**MEMORANDUM – REDACTED VERSION – JULY 19, 2007**

**Subject:** Update of Current Knowledge Regarding the State of Integrity of OCNCS Drywell Liner and Comments Pertaining to Aging Management Thereof

**Subject: Review of Fitness for Service Assessment of Oyster Creek Dry Well  
on the Basis of Extended Data Analysis**

Figure 2

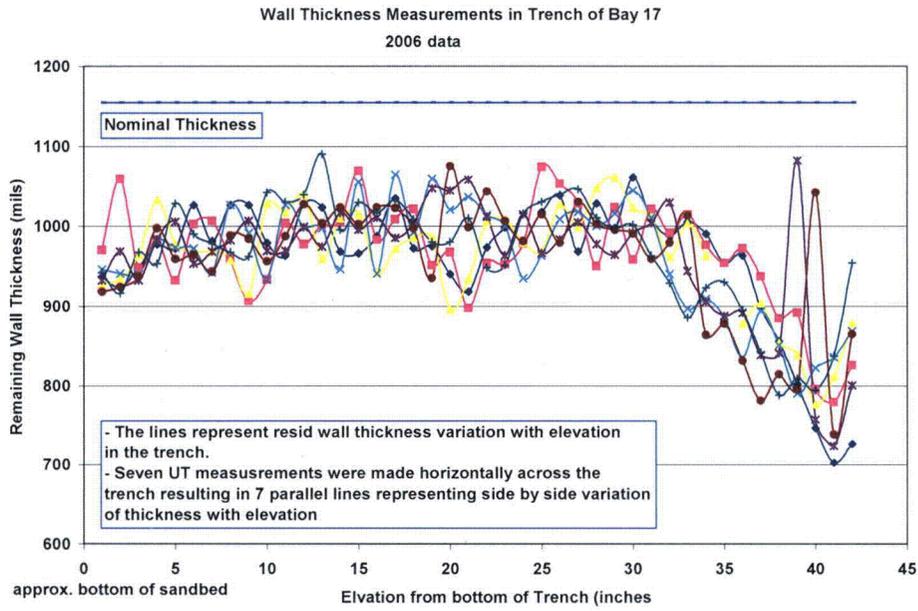
We take issue with this statement. In support of this contention, an effort was made to show graphically the remaining wall thickness observed in all of these various locations. Thus Figure 2 shows, by way of example, the remaining wall thickness from the 2006 UT measurements made with the help of 6 by 6 inch grids as a function of elevation in the trench of Bay 17. It is understood, as is described in Ref. 3 that 6 such grids were placed one on top of the other in the trench in order to capture the corrosion from the bottom to the top of the sandbed. Hence, if the bottom of the trench had the elevation about 9 feet, then the top of the 6 grids would have had an elevation of about 12 feet, which according to Figure 1 corresponds to the top of the sandbed and is at least 9 inches higher than the top of the grid used for UT measurements from the inside. (Note, none of these elevations is terribly accurate, however, the top of the trench measurements were definitely lower (deeper pits) by a good margin than the inside grid measurements). Figure 2 plots all individual 2006 measurements from the trench in bay 17. The 6 traces represent the variation of the wall thickness in the horizontal direction while the traces themselves extend from the bottom of the trench (left hand side) to the top of the trench (right hand side). The

undulations of the 6 traces, which are at times (at the same elevation) in synch and at other times out of phase clearly depict the nature of the “golf ball type” surface described in AmerGen literature (Ref. 1 pg. 4). Where the undulations are in synch one can estimate that the extent of the pit at that location extends over an area larger than just one inch in diameter<sup>3)</sup>. It should also be noted that the average amplitude of the undulations in Fig. 2 are of the order of 0.1 inch, i.e. the roughness of the surface at this point is only of that order of magnitude. AmerGen estimated the “roughness” of the surface to be rather of the order of 0.2 inches (Ref. 5 pg. 5).

The most striking observation is that the corrosion is most severe at the top, almost uniform in severity over most of the depth of the sandbed and again somewhat more severe at the very bottom.

Figure 3

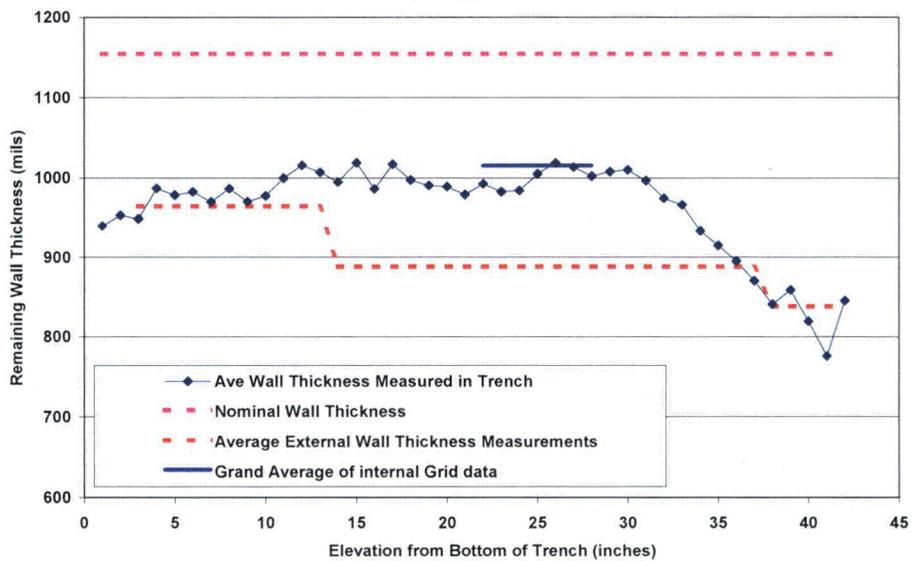
In Figure 3 an effort is being made to compare the average remaining wall thickness from trench measurements (averaged over the horizontal direction) with the average of the 6 by 6 grid measurement from the inside and the direct UT measurements from the outside. Also graphed in this figure are the averages of the outside measurements for the three zones for which data are reported (Ref. 5). What one can see is that the averages for the grid and the trench data overlap quite well at the same elevation. However, the average outside measurements are significantly lower at comparable elevations.<sup>4)</sup> This is probably because the choice of location for the external measurements was deliberately biased towards thin spots.

Figure 4

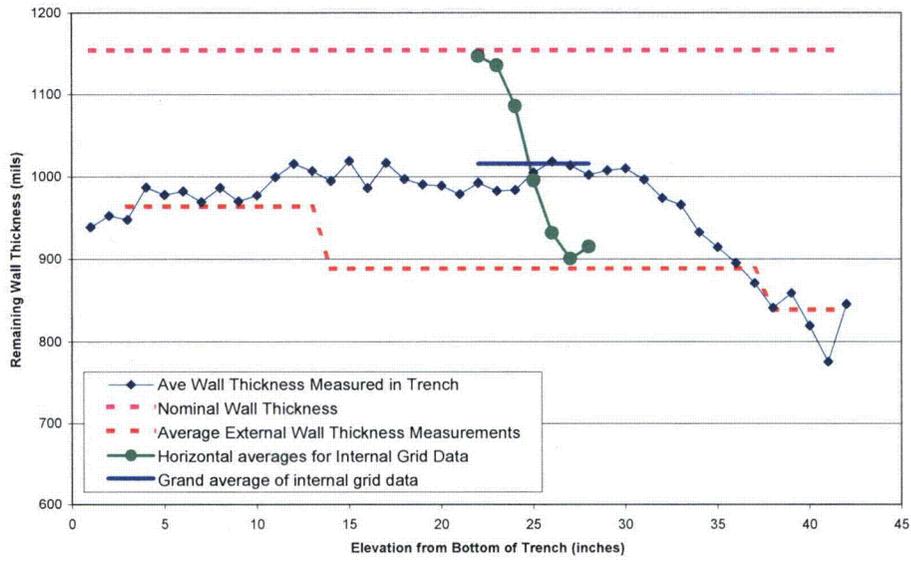
Finally in Figure 4 we see the spread of the 6 by 6 inch inside grid measurements superimposed on the averages of the other measurements.

**Conclusion:** What the superposition of the UT measurements in Bay 17 demonstrates is that wall loss ranges from zero to 33 percent, however, only the trench and outside measurements come close to represent the most severe corrosion at the highest elevations. It should also be remembered that the grid measurements at the inside curb cutout as well as those in the trench are only 6 inches wide. One does not have, therefore any indications as to how far serious corrosion may have spread laterally around the circumference of the bay.

Figure 5

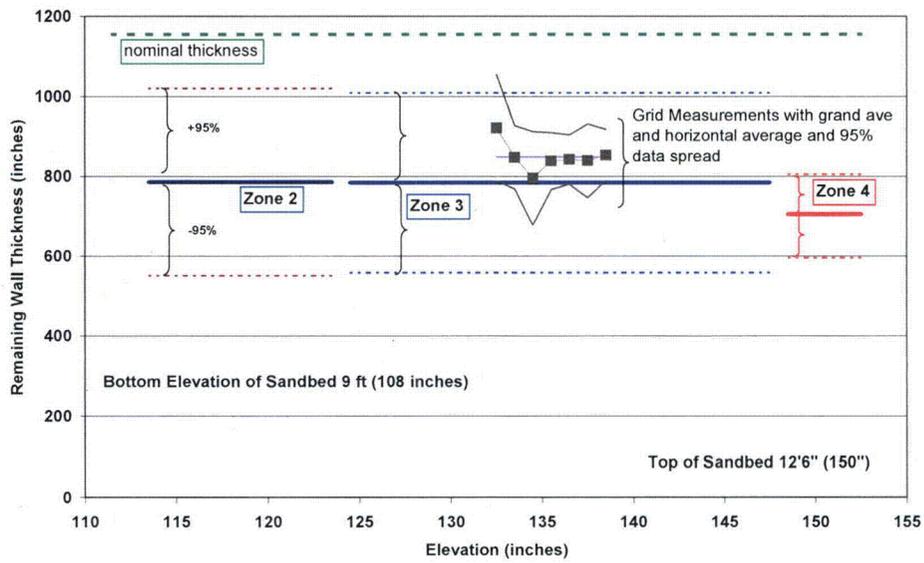
Figure 5 shows an analysis of the available 2006 data for Bay 13. Bay 13 is probably the second worst corroded bay apart from Bay 1. The averages for the external measurements for each zone are fairly similar, as are the 95% limits for the data spread. There is a 95% percent probability for the deepest penetration to be of the order of 48% of the original wall thickness. The superposition of the internal grid data shows a higher average and a narrower distribution of the data spread. Again one recognizes that the internal 6 by 6 inch grid measurements do not represent the worst corrosion degradation.

Figure 6

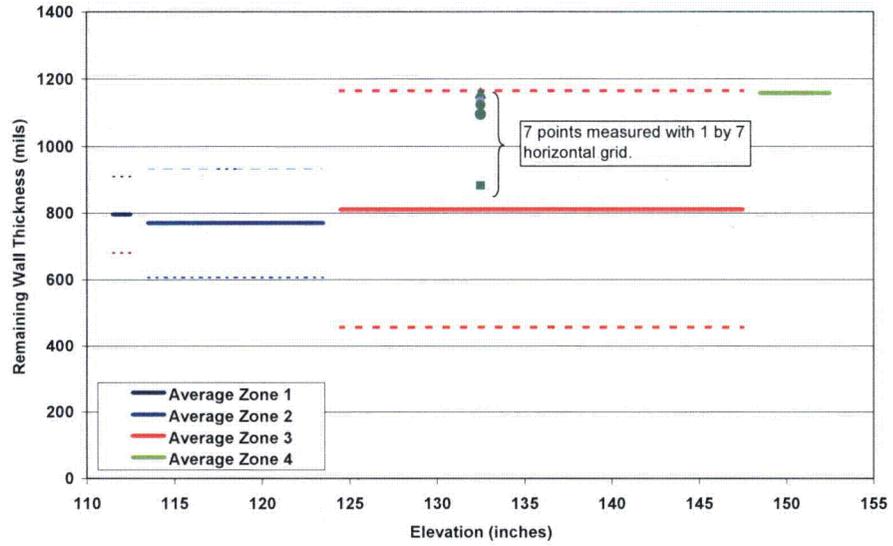
Finally in Figure 6 we show the distribution of the external measurements for Bay 1. One observes that the 95% lower limit of the data spread is around 40% of the original wall thickness, or indeed at a remaining wall thickness of 450 mils, which is 0.04 inches below the required sandbed thickness for the Design Pressure and Temperature. Because the external sampling in Bay 1 was designed to capture the thinnest points, this is a conservative estimate of the minimum wall thickness. However, given the need for a very high degree of confidence that the drywell shell is ready to withstand accident pressures and the uncertainty created by the sparse data set, I believe that a conservative approach is required in this case.

### Statistical Analysis of all External UT Measurements

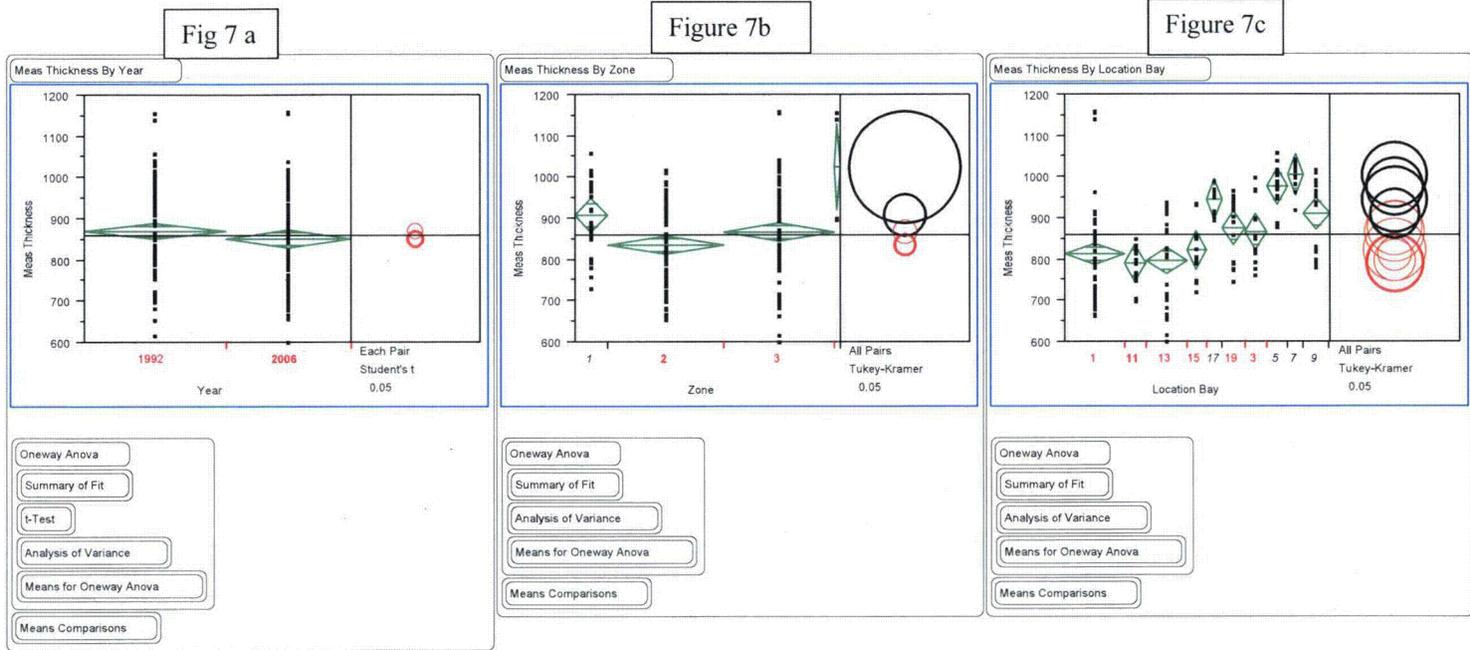
It was found that there is no significant effect of the time (Fig.7a). While there is a decrease of 19 mils between 1992 and 2006, this difference is not statistically significant within the variability of the data. The differences between the zones, however are significant. Zone 2 is by far the most corrosive zone. When the bays are compared, one finds as expected that some bays have experienced little corrosion in contrast to others. The importance of these observations is obvious: they point again to the fact that the intensity of corrosion is a clear function of elevation and bay. Hence, averaging data and generalization may lead to doubtful conclusions.

Comments: Figure 7a: Comparison between measurements I 1992 and 2006 show no significant difference. The means from 1992 and 2006 show a bias of 0.018 inches, but the bias is statistically not significant despite of the many data points. Fig. 7b: The comparison between the “zones” (elevations) is significant. Zones 1 is significantly different from zones 2 and 3. For zone 4 there are not enough data for statistical significance. Fig. 7c: Some bays, red ones, are significantly different from the black ones.

**Figure 10: External UT measurements in Bay 19**

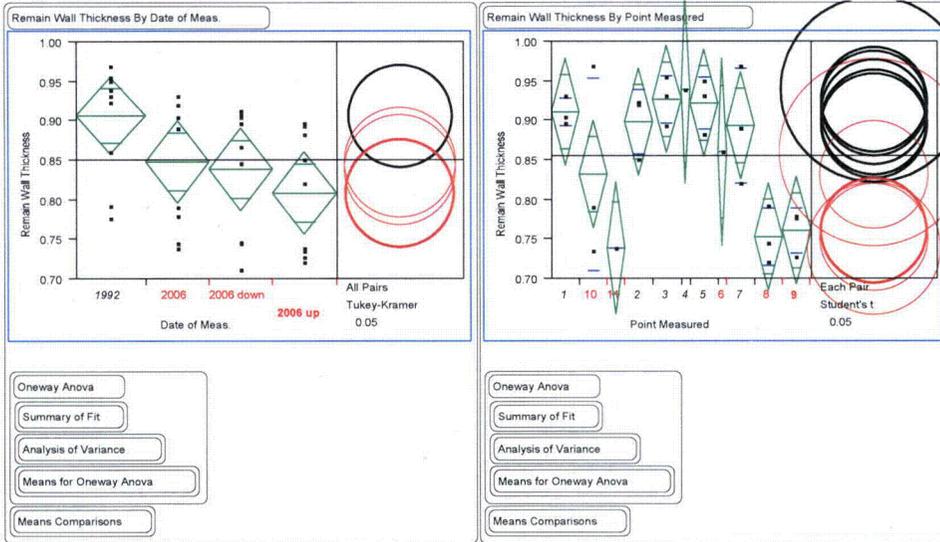
identified as 2006 up and 2006 down were compared with the original 2006 data. It turns out for Bay 19 for instance that the UT penetrations identified as 2006 up were significantly lower than the measurements of 1992 with a probability of better than 95%. The difference between the 1992 and 2006 up data is 0.1 inch. Similarly for Bay 15 one finds that the 2006 up data are significantly lower than the original 1992 data by about 0.06 inches, although this difference is not significant at the 5% level. For Bay 1 there is practically no difference between the 2006 and the 1992 data sets, because of the two or three measurements in the non-corroded areas. Summarizing these results in Table 1, one finds that the lower 95% confidence limits for Bays 1, 15 are marginally within the 0.736-inch limit. Since one does not know exactly how extensive the "cancer of corrosion" in the sand bed area really is, it is very difficult to put this interpretation in perspective with the assessments made by AmerGen relative to areal criteria for thinned areas (see discussion below).

Again one finds that the “up” measurements are significantly lower from the 1992 measurements.

Figure 1

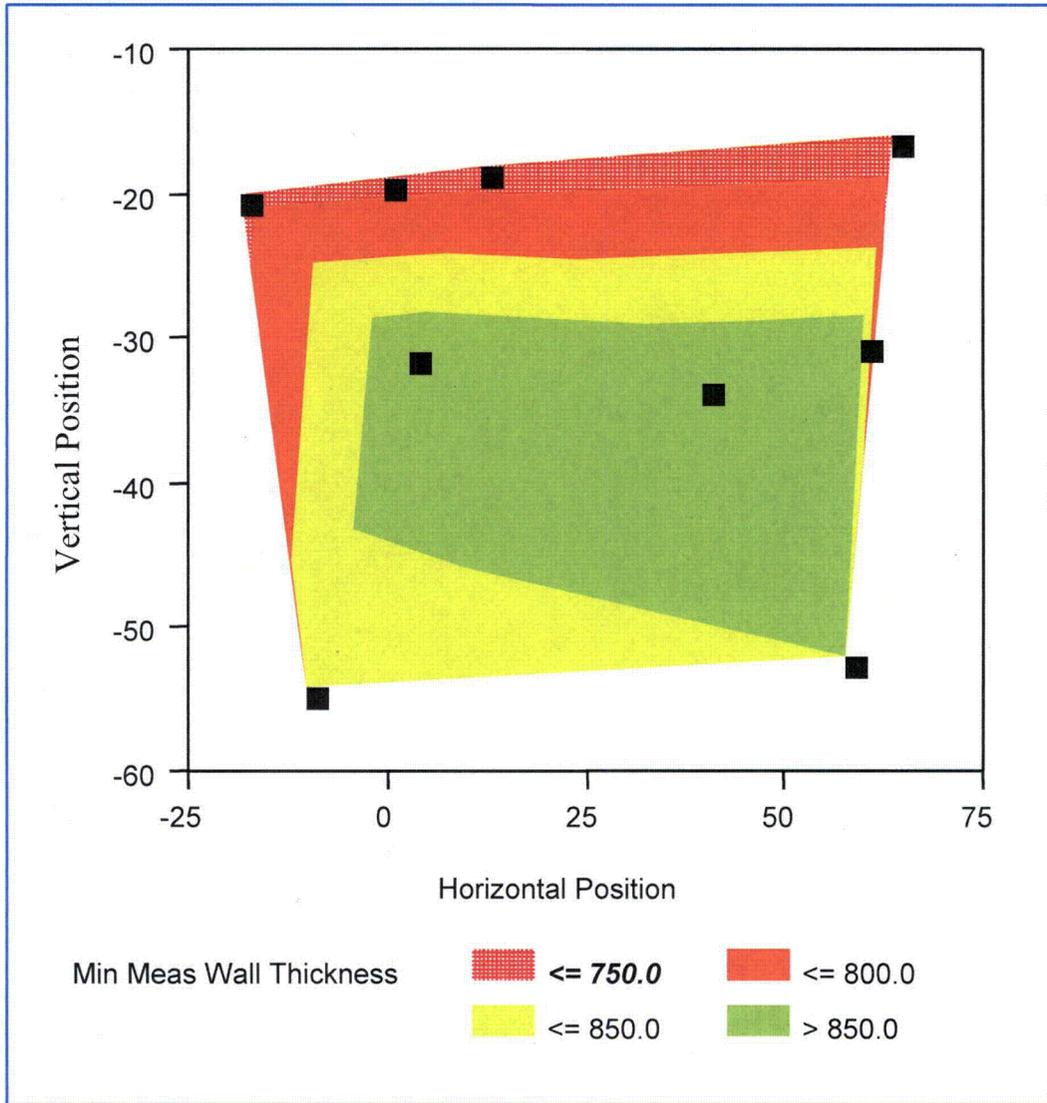
The advantage of this evaluation is that one can see all the available data in a quantitative presentation. Thus, one can see in Figure 1 that an area exists at elevation -20 (20 inches below the reference point) where the remaining wall thickness is less than 750 mils, or less than the criteria for general thinning at 95% confidence. This area extends from 20 inches on the left (-20 inches) to about 60 inches on the right (+60 inches), or about 7 feet. The width of this area in Fig. 1 is maybe 4 to 5 inches, however, because measurements were not extended toward lesser elevations (from the reference point) one simply cannot estimate how much further the serious the corrosion may extend in Bay 19.

**Figure 1** mentioned previously shows a heavily corroded area in Bay 19 at elevation -20. The extent of this area is highly uncertain because it was not further defined by additional UT measurements toward higher elevations (>-20). Indeed, one could find here an extended bathtub ring area.

**Figure 2**

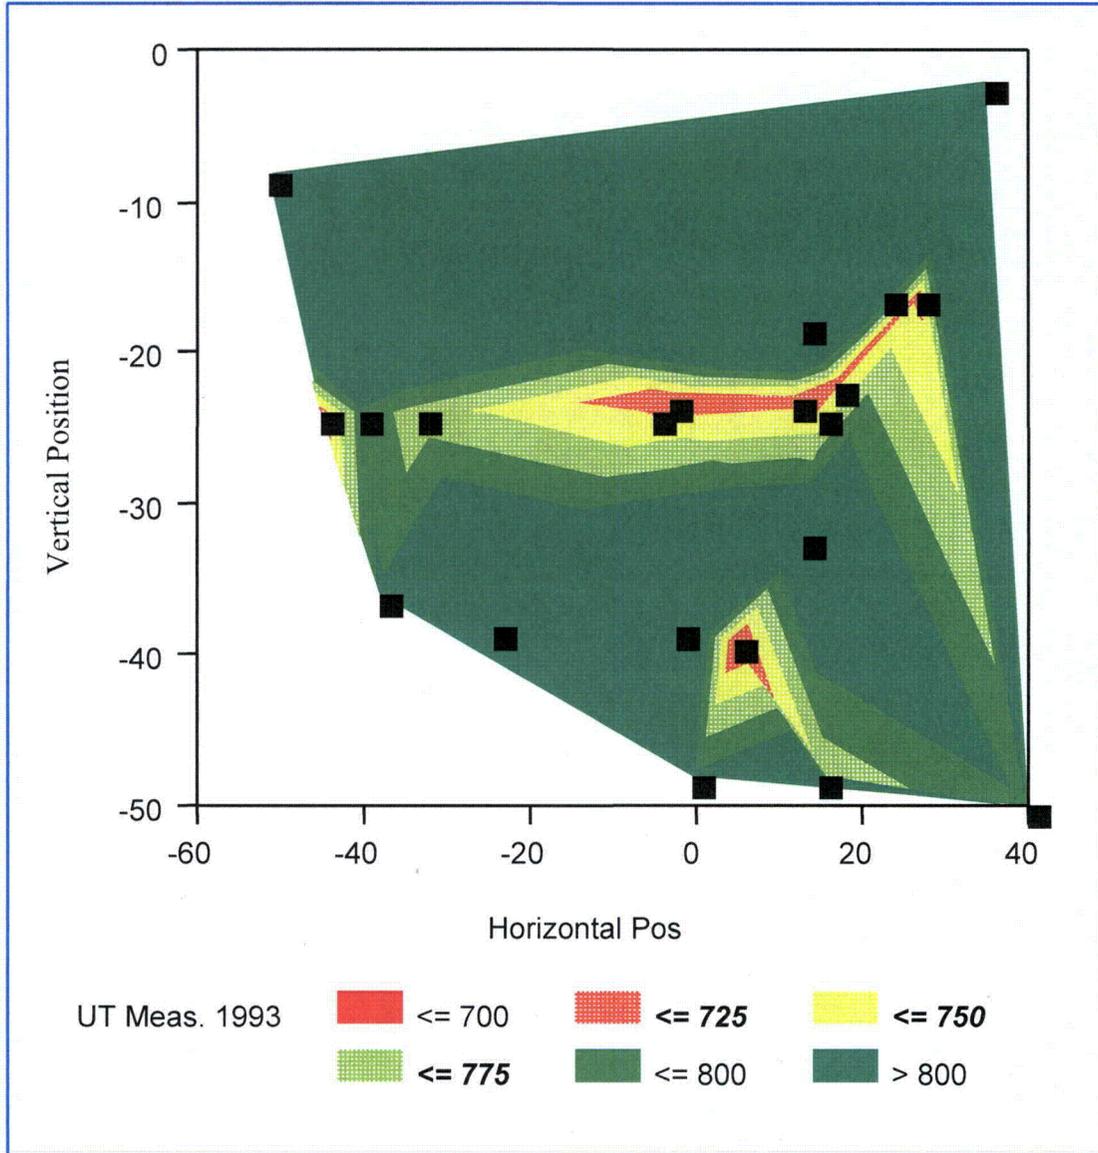
The data used for the analysis are contained in Tables 1 and 2, which were extracted from AmerGen documents. Presumably, the data were obtained from Bays 1, 5, 7, 15, and 19. Figure 2 shows a contour plot for Bay 1 obtained with the dimensions of the points in the plot are 2.5 by 2.5 inches. Remember that the specific shape of the contours depends on the wall thickness measured at the locations indicated, but also on the measurements as well. (For instance, an additional measurement at (20) v (-25) could completely alter the contours and indicate a wall thickness below -750 mils<sup>4</sup>).

Nevertheless, it appears in Figure 2 that in the so-called "bathtub ring" area exists with wall thicknesses between 700 and 750 mils. This area extends well over 52 inches (4<sup>+</sup> feet) and is about 5 inches wide. In view of the fact that UT measurements are at best accurate with a standard deviation of about 45 mils (95% confidence limits +/-90 mils), this area could well be more extensive.

**Figure 3**

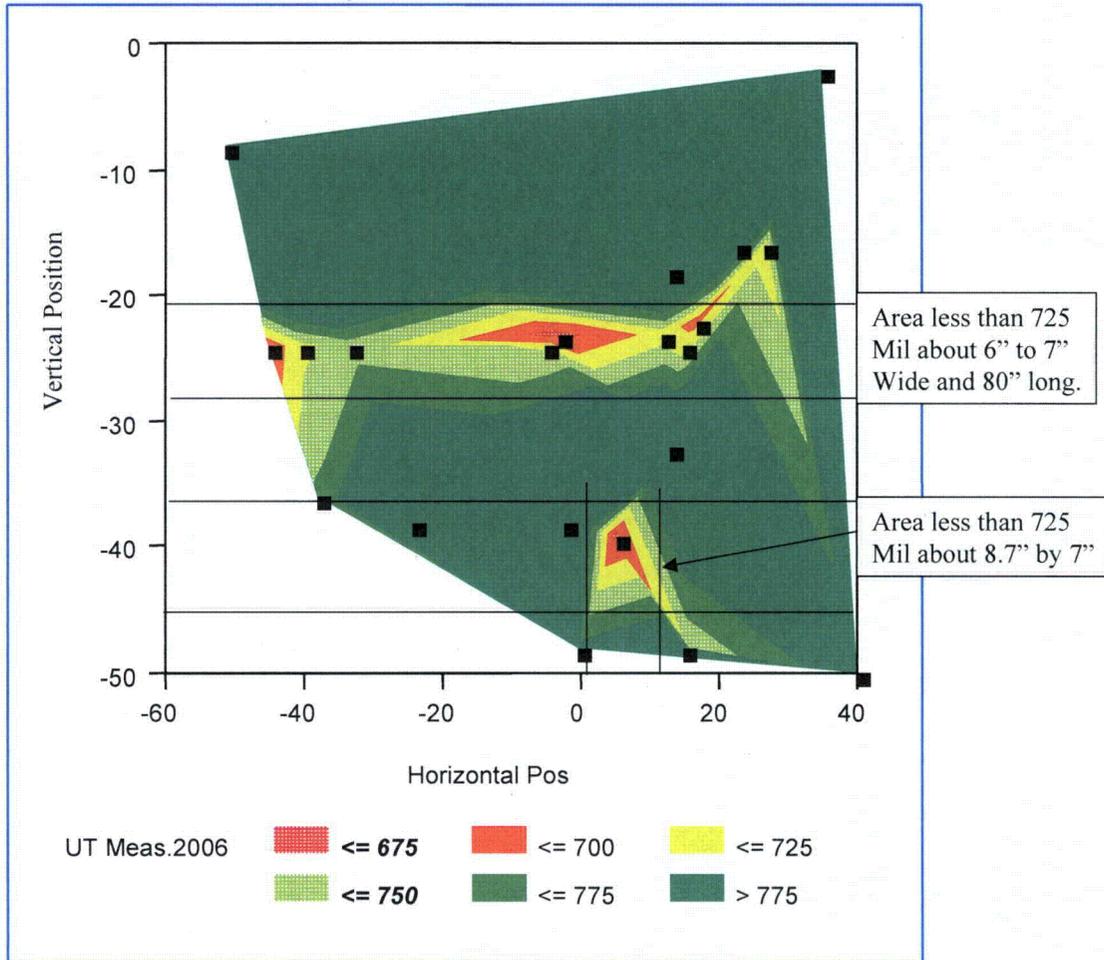
Figure 3 shows the contours for Bay 1 obtained with the data from the 2006 inspection. The general shapes are the same as in Figure 2, but there are sizeable areas with residual wall thicknesses below 720 mils.

that these areas seem to extend on the left beyond h -40 inches but no measurements are available to verify whether AmerGen did in fact manage to capture all of the most corroded areas as claimed.

Based on Figure 3, together with an assessment of the accuracy (reliability) of the data one must conclude that there is a good likelihood that the entire bathtub ring area extending from 40 to -40 inches on the horizontal axis and from about -30 to perhaps -20 inches on the vertical axis is below the 0.736 inch criteria for general thinning and is, much larger than the one square foot acceptance criterion. (Of course, since this area is the most corroded, it will taper off to higher wall thickness on both sides of the vertical axis). The corroded area is indeed shaped quite irregular, but one could venture a guess that the contoured areas below 750 mils are of the order of 4 to 7 square feet all together. This estimated area does not include the area to the left of -40, which probably contains additional area below 0.750 inches.
